## PROJECT OVERVIEW

MASTER PLAN FILING OF A MAJOR LAND DEVELOPMENT  
for a Proposed  
COMMERCIAL SELF-STORAGE FACILITY

850 MANTON AVENUE  
PROVIDENCE, RHODE ISLAND  
AP 34, LOT 381  
ZONING DISTRICT: C-3 (HEAVY COMMERCIAL DISTRICT)

**CONCEPTUAL SITE PLAN**

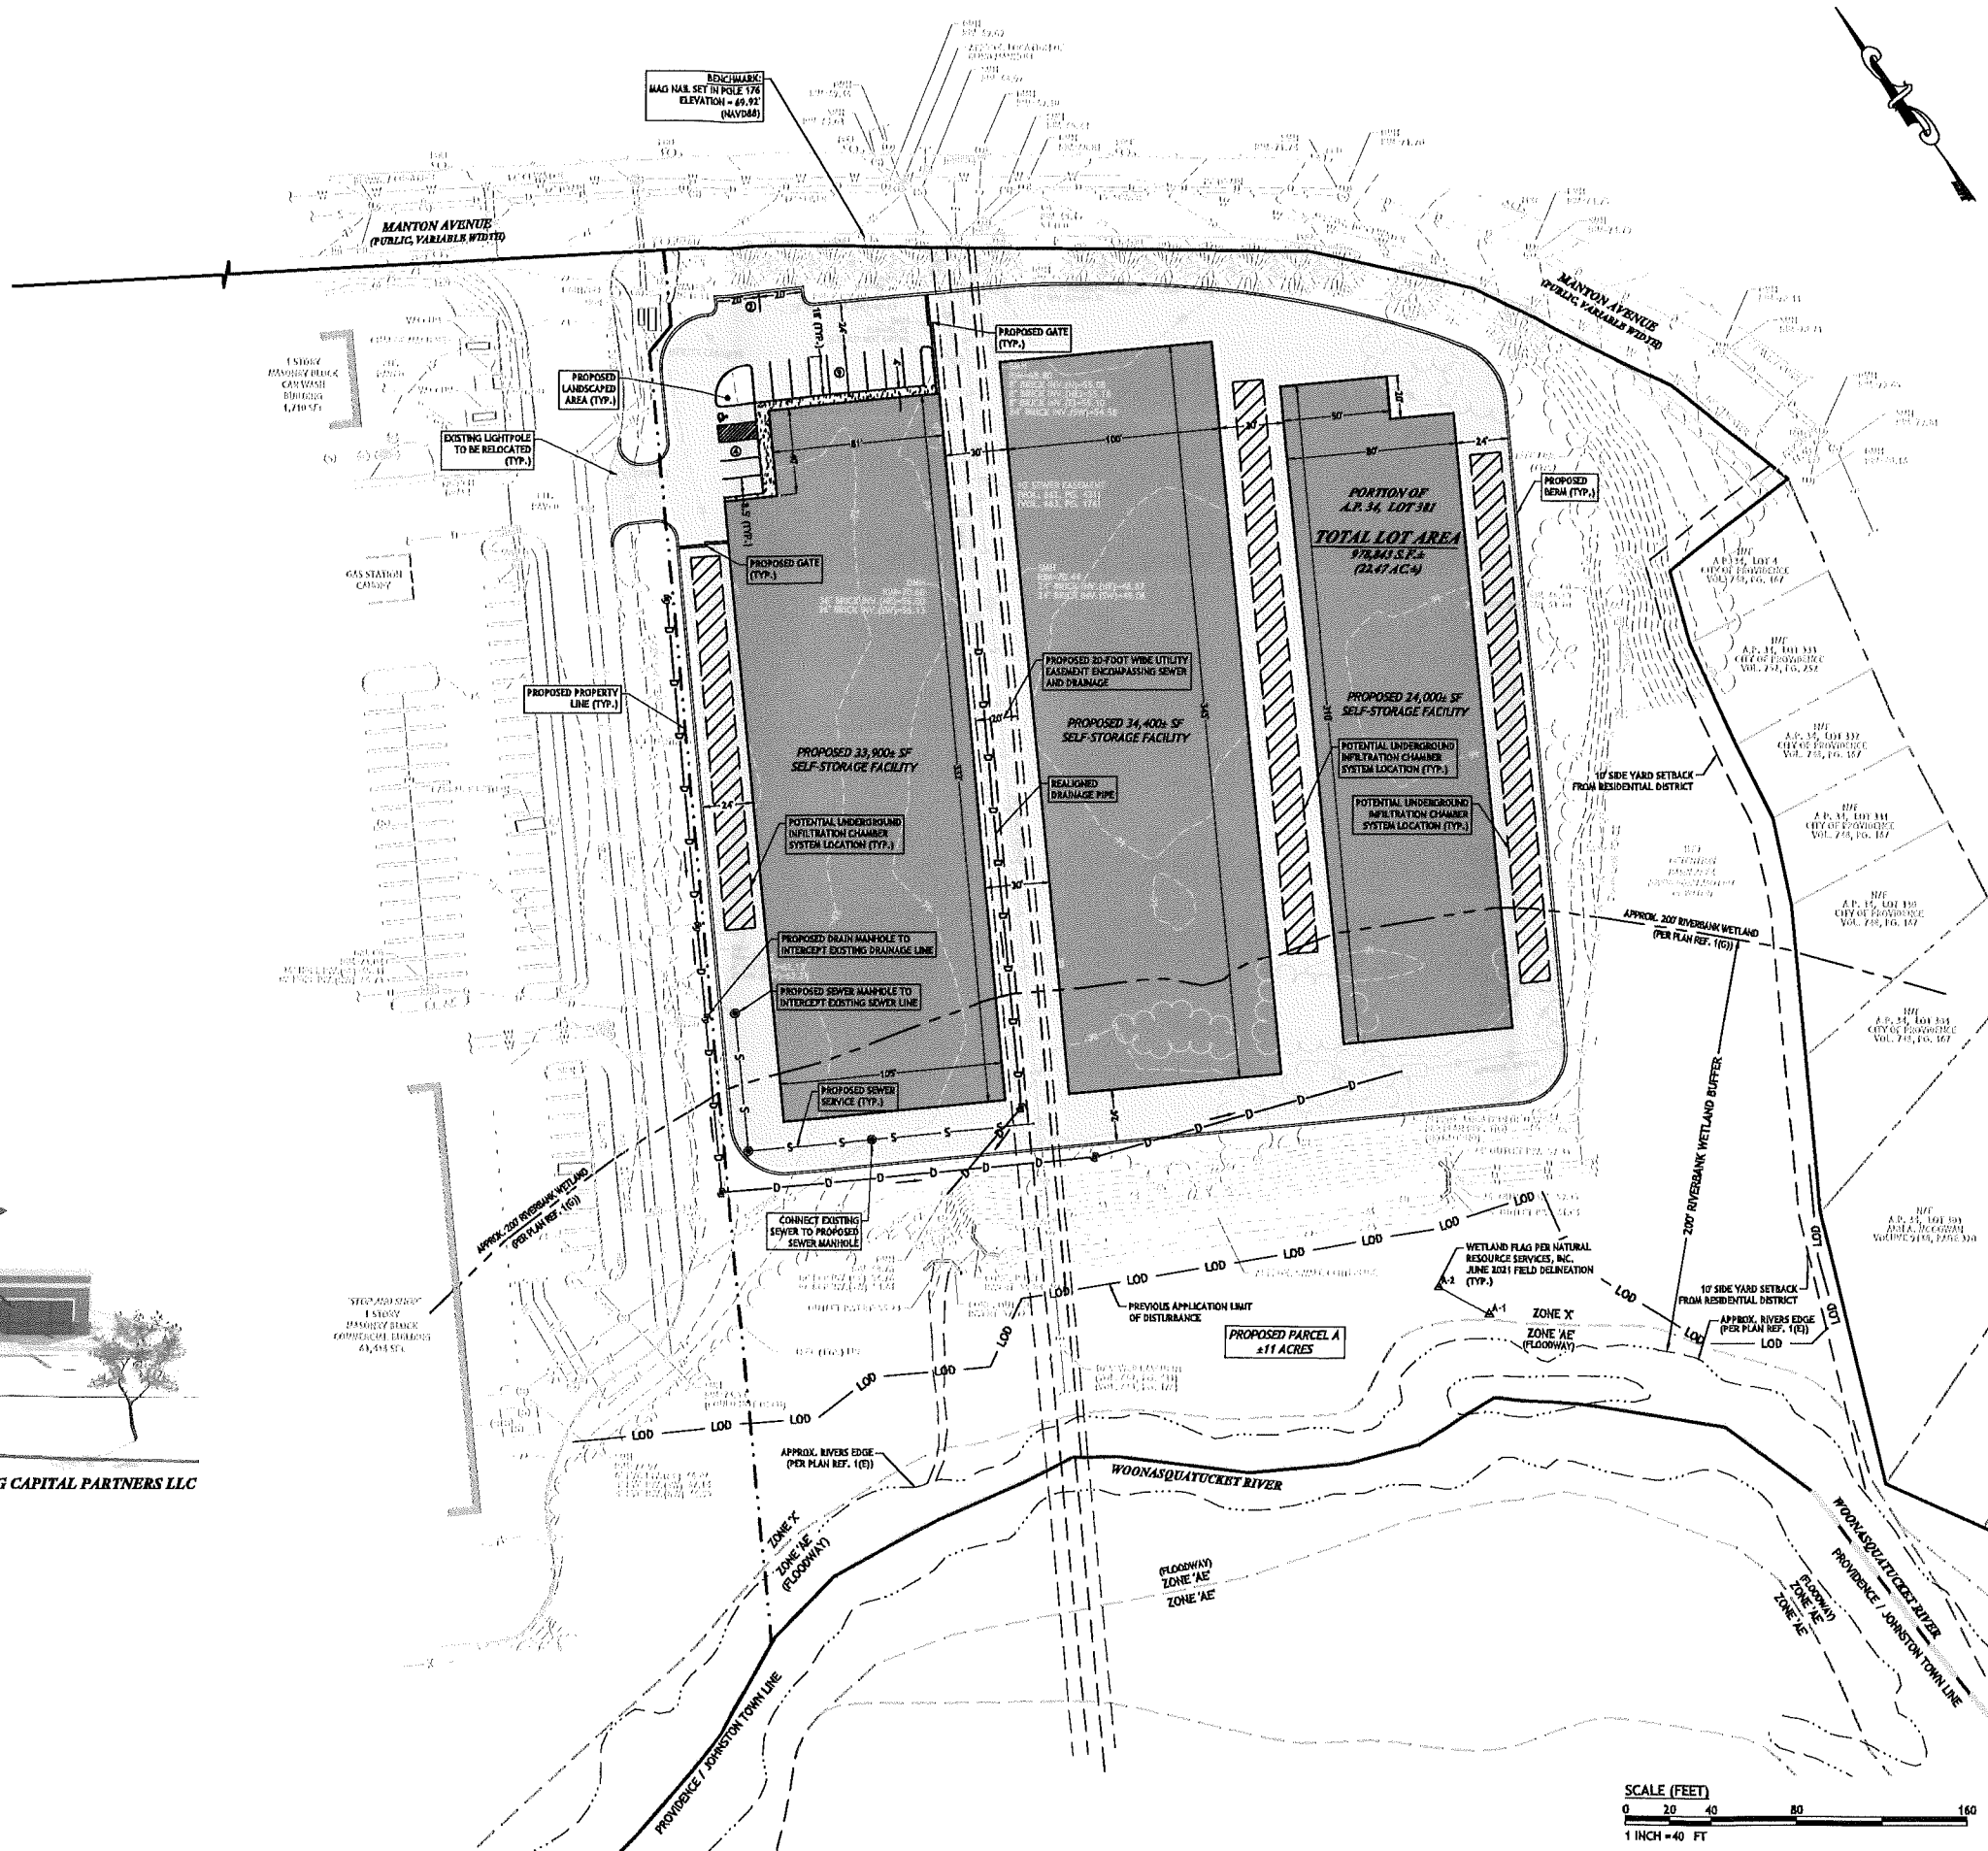
The development will be composed of three one story storage buildings with storage bays on each façade, set back from Manton Ave. A total of 720 units are proposed across the three buildings. Lot access will be provided from a driveway that originates on Manton Ave. The westerly building will contain an office of approximately 900 SF with 15 parking spaces located in proximity. Site improvements like landscaping, lighting and utility connections will also be provided.

Based on conceptual building designs, it appears that design waivers will be required for minimum building height, façade materials and fenestration. The C-3 zone requires a minimum height of 11 feet but 10 are proposed. The building facades are characteristic of storage spaces with corrugated metal for entry bays and no fenestration. EIFS is proposed on the building facades. Design waivers from the C-3 design requirement of 50% ground floor transparency and

prohibition of corrugated metal and EIFS on facades are required based on the submitted design. The applicant is requesting that the waivers be deferred to the preliminary plan stage when detailed building designs will be developed.

1. The CPC should grant the waiver from submission of a conceptual landscaping plan subject to the condition that a detailed plan be submitted at the preliminary plan stage.
2. The CPC should defer consideration of the requested design waivers to the preliminary plan stage.
